# SERVICE NO. 1399 **BULLETIN**

(S) Date: March 16, 2023

WING RIB MODIFICATION SUBJECT:

Figure 1 Nose Rib Inspection

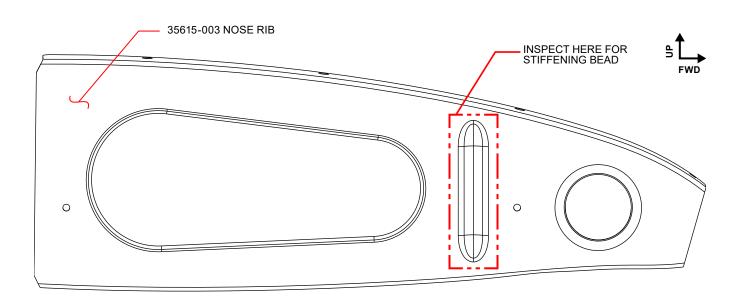
- 2. Gain visual access to the right wing WS 206.70 Nose Rib, Piper P/N 35615-003, as shown in Figure 1.
- 3. Examine the Nose Rib for the presence of a stiffening bead at the location identified in View A-A.

- If the WS 206.70 Nose Rib has the stiffening bead feature, no modification is required. Proceed to step 6.
  - If the WS 206.70 Nose Rib does not have the stiffening bead feature, modification of the Nose Rib is required. Proceed to step 4.

Figure 2 Stiffener Angle (P/N SB1399-1) Fabrication

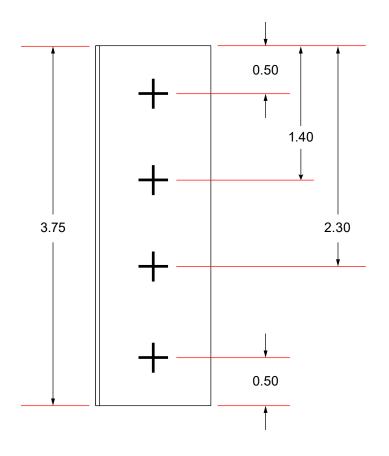
- 4. Fabricate a Stiffener Angle, quantity one (1) each per aircraft, as defined in Figure 2. This Stiffener Angle shall conform to the following specifications:

- Material: 0.040 thick 2024-T3 aluminum sheet conforming to AMS-QQ-A-250 and AMS-QQ-A-250/5. Procure locally.
  - Finish: Apply primer that conforms to MIL-PRF-85582D Type 1 Class C2, or, any one of the primers listed in Table 1. Procure locally.

- All dimensions shown are in inches. Tolerance on linear dimensions is  $\pm$  0.050 inches. Tolerance on bend radius is  $\pm$  0.030 inches.
  - After the primer has cured, mark the Stiffener Angle with P/N "SB 1399-1" using a permanent felt tip marker, with minimum text height 0.25 inches. Locate the part number on a surface that will be visible after installation on the aircraft.

**Figure 3**Stiffener Angle Installation

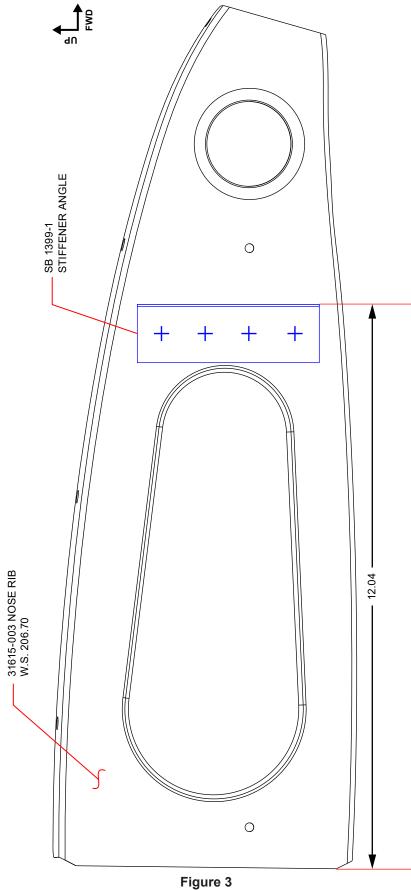
- 5. Install the SB 1399-1 Stiffener Angle as shown in Figure 3.
  - a. Adjust the vertical position the SB 1399-1 Stiffener Angle so that the clearance from the upper and lower flanges of the WS 206.70 Nose Rib is the same,  $\pm$  0.05 inches.
  - b. Install four (4) MS20470AD3 series rivets (aka "BJ 3") to secure the SB 1399-1 Stiffener Angle to the outboard side of the 35615-003 WS 206.70 Nose Rib. Procure rivets locally.

Alternatively, protruding Cherry-max type blind rivets may be used, -4 size only, provided the shank is aluminum, the stem is corrosion resistant steel, and the manufacturers recommended rivet puller and rivet puller head are used.
